DRAFT
STANDARD REVIEW PLAN
for *In Situ* Uranium Mining
License Applications

Revision 0

U.S. Nuclear Regulatory Commission

May 1997

Figure 1. Licensing process for 10 CFR Part 40 licenses

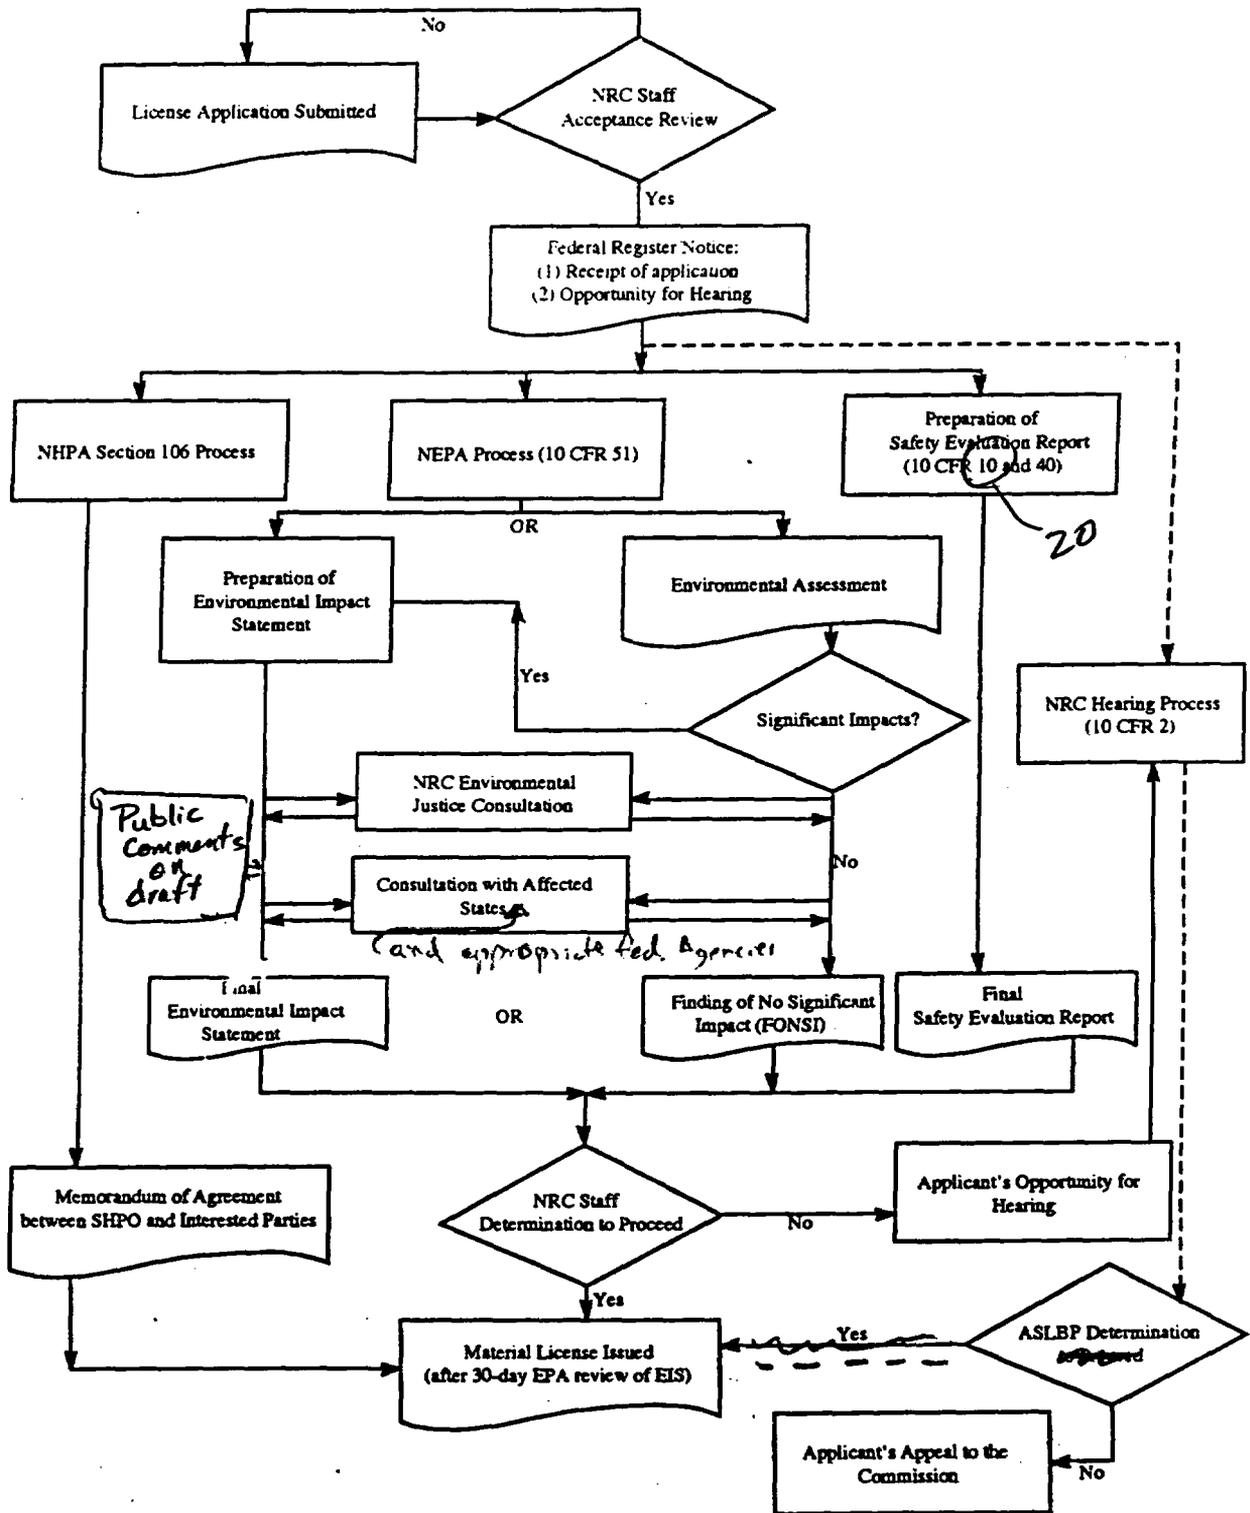
Replace with Annex A

*Insert B
Don't know*
